Subject: Project Enhancement and Refinement Document
Carlsbad Energy Center Project (07-AFC-6)

Carlsbad Energy Center Project (07-AFC-6) Project Enhancement and Refinement Document

Submitted by
Carlsbad Energy Center LLC

July 2008

**REVISED FIGURE DR111
ENCINA POWER STATION OUTFALL
CARLSBAD BOULEVARD
EXISTING VIEW AND VISUAL SIMULATION**
CARLSBAD ENERGY CENTER PROJECT

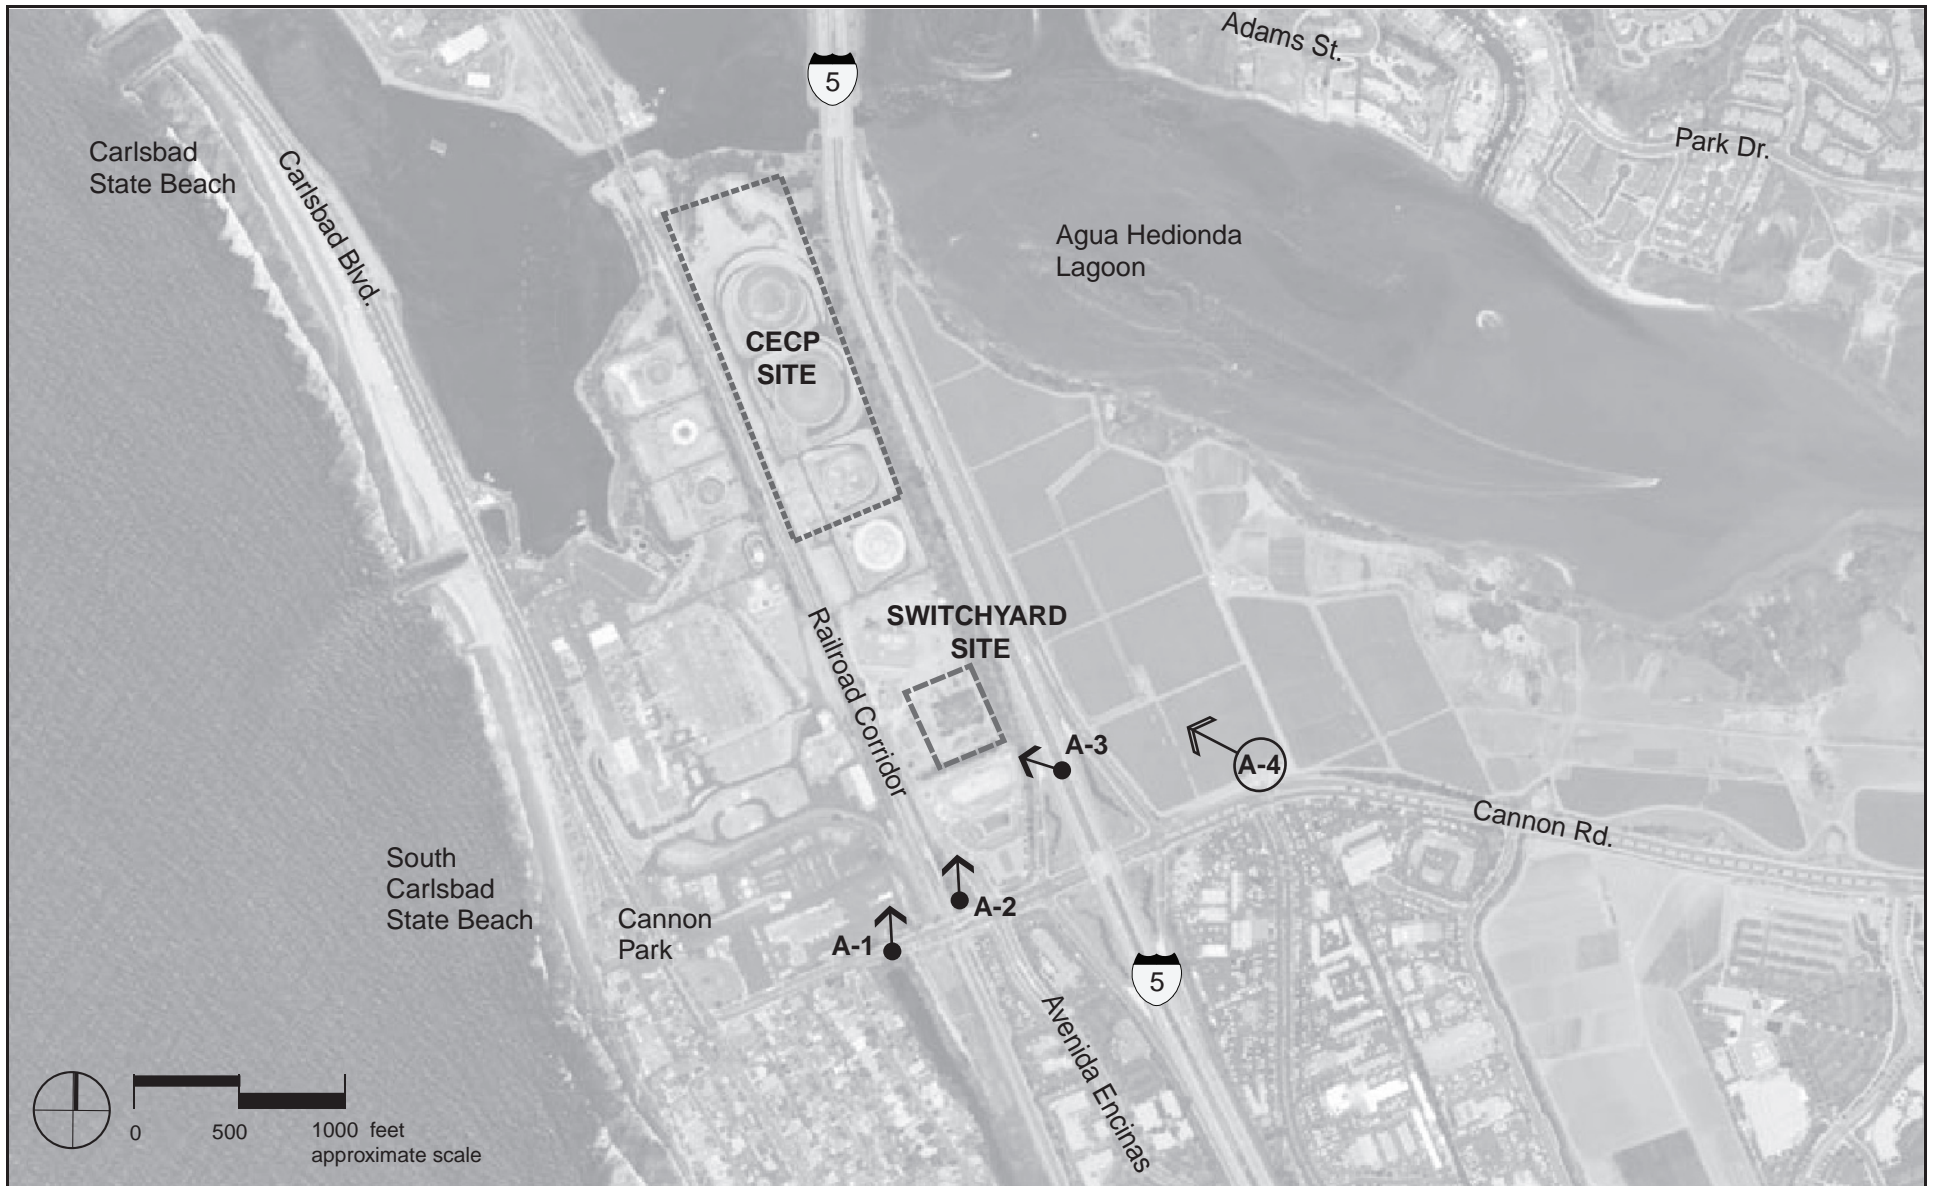
Stack height is shown at 139 feet
